## Android Indoor Station Firmware Release Note

### V2.2.26\_build230807 (2023-08-10)

Firmware Basic Information	Firmware Version	V2.2.26_build230807
	Device Model	DS-KH9310-WTE1(B) DS-KH9510-WTE1(B)

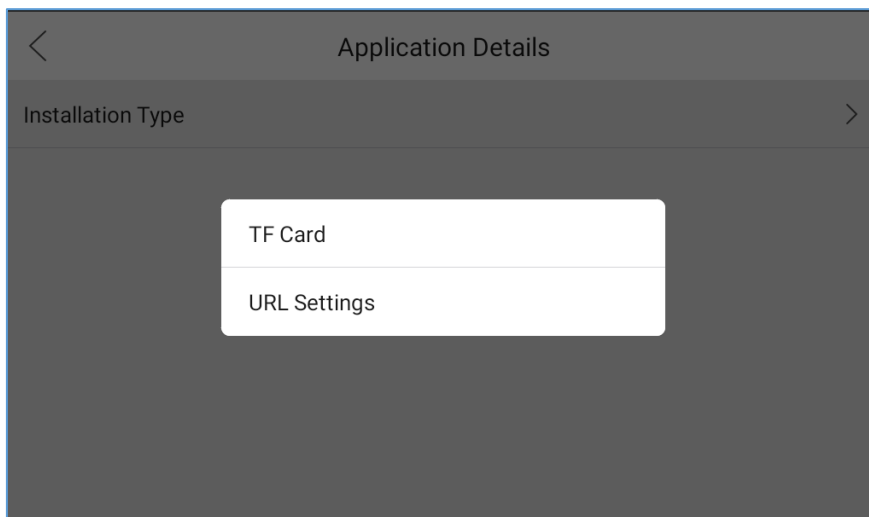
1. Support 16 indoor extensions.
2. Support 5 apps maximum (was 2 in previous version), total storage  $\leq$  1 GB, RAM  $\leq$  500 MB, CPU  $\leq$  30%

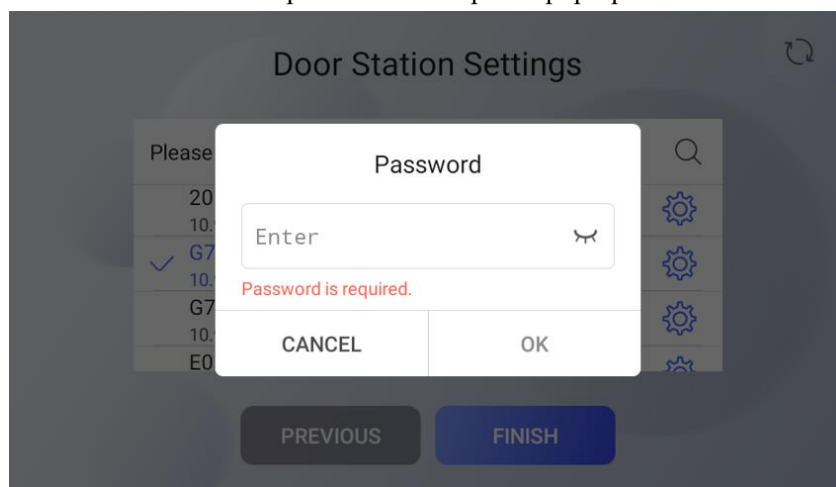
2. Add new function in wizard to check whether the activation password of the door and indoor station are the same, if not, it will prompt to enter the door station password in a separate pop-up box.

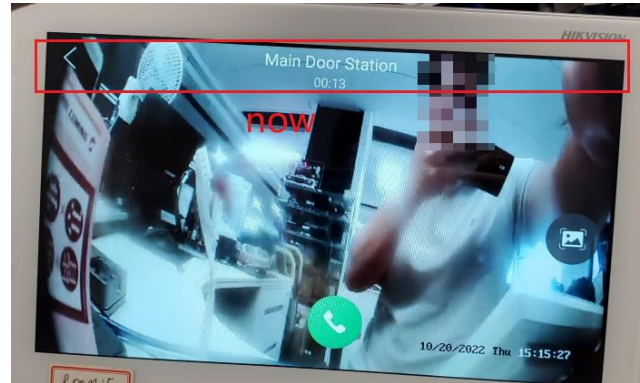
1. Change the gradient background at the top of the preview screen to transparent

Live View

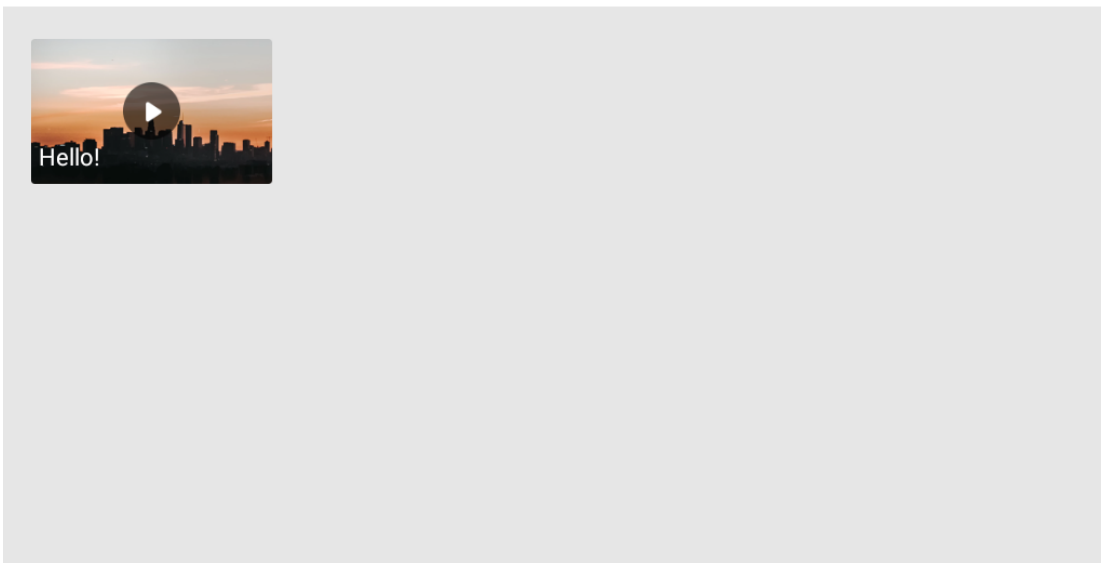
1. Extends the limited third-party resource. (Memory 500 M CPU 30% flush 1G)
2. Displays custom device name on the live view list and the corresponding live view website page.

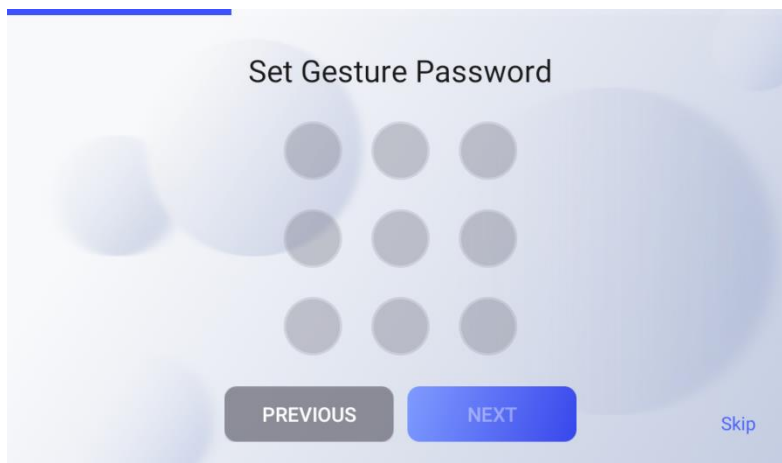
#### 2) Support unlock via gesture.

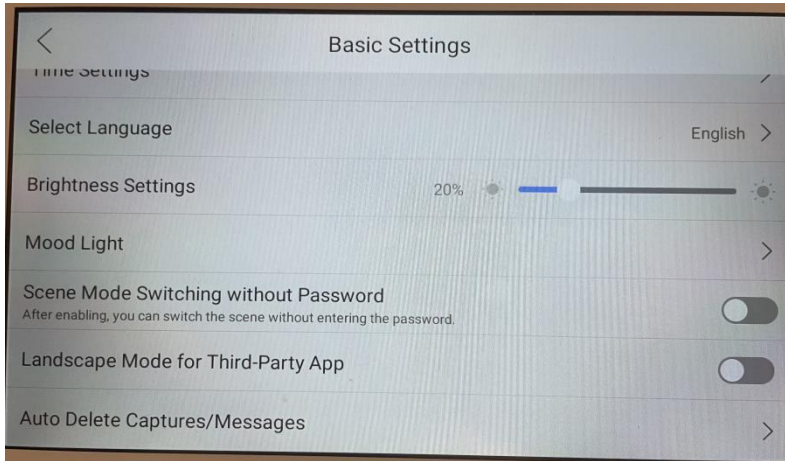
#### 3) Support captured image, message auto-deletion function.

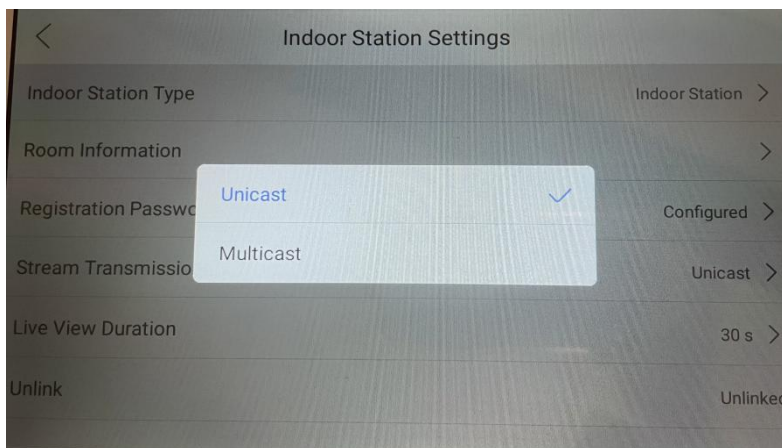
### 1) Support unicast and multicast options for video stream.

For multicast mode, the new version is supported up to 15 channels of video stream, but the switch or router must support the multicast mode at the same time, otherwise it can only support 6 channels of video stream.

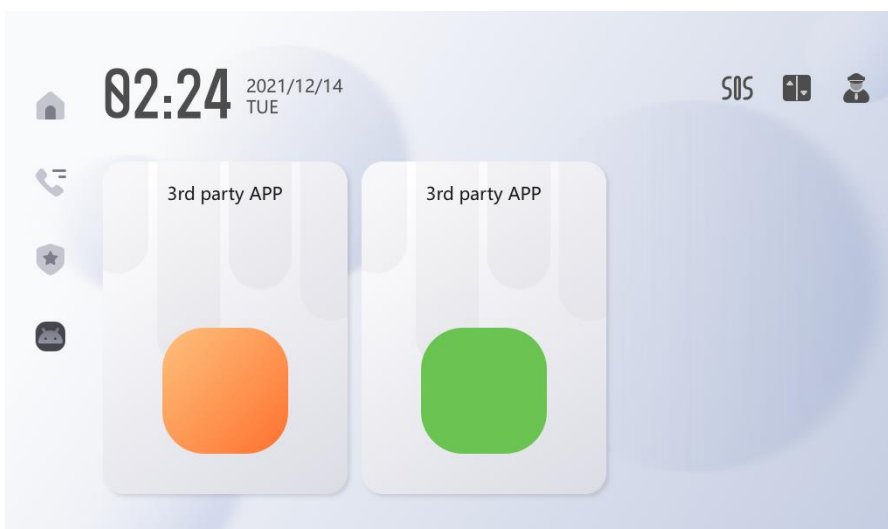
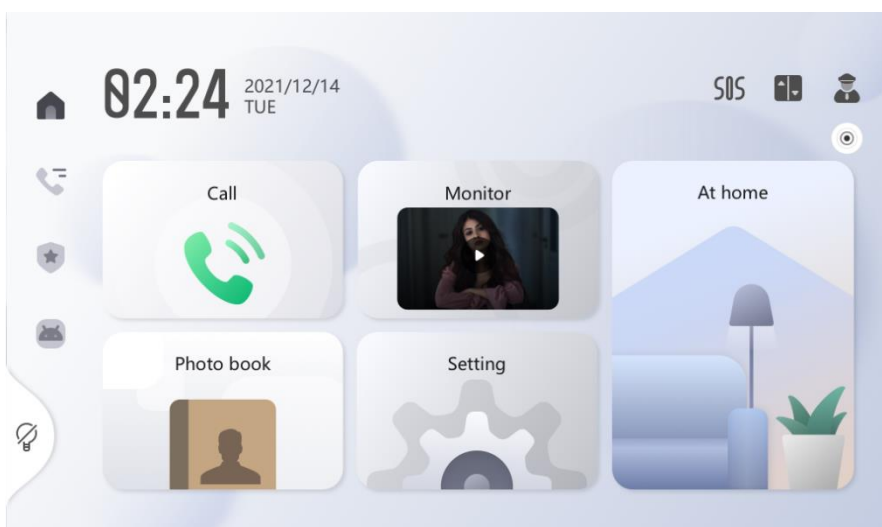
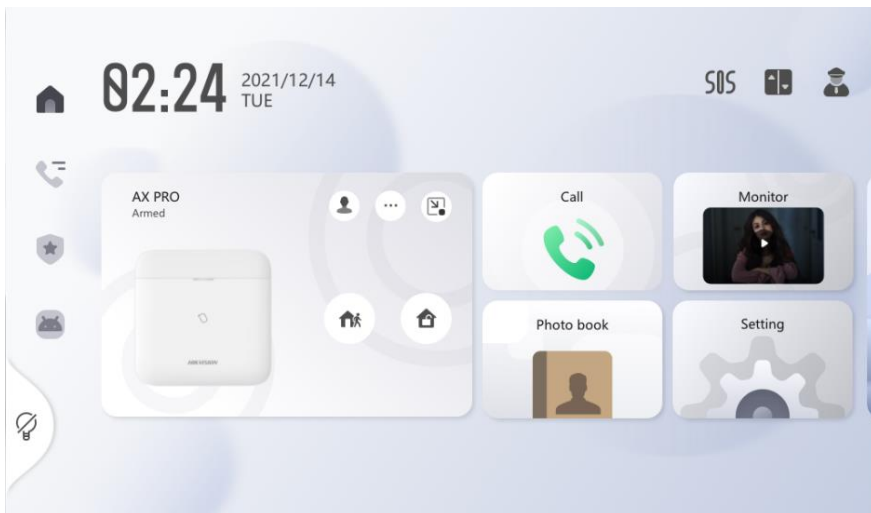
### 2) 22 languages are supported

English, French, Portuguese (Brazil), Spanish, Russian, German, Italian, Polish, Arabic, Turkish, Vietnamese, Hungarian, Dutch, Romanian, Czech, Bulgarian, Ukrainian, Croatian, Serbian, Greek, Norwegian, Danish
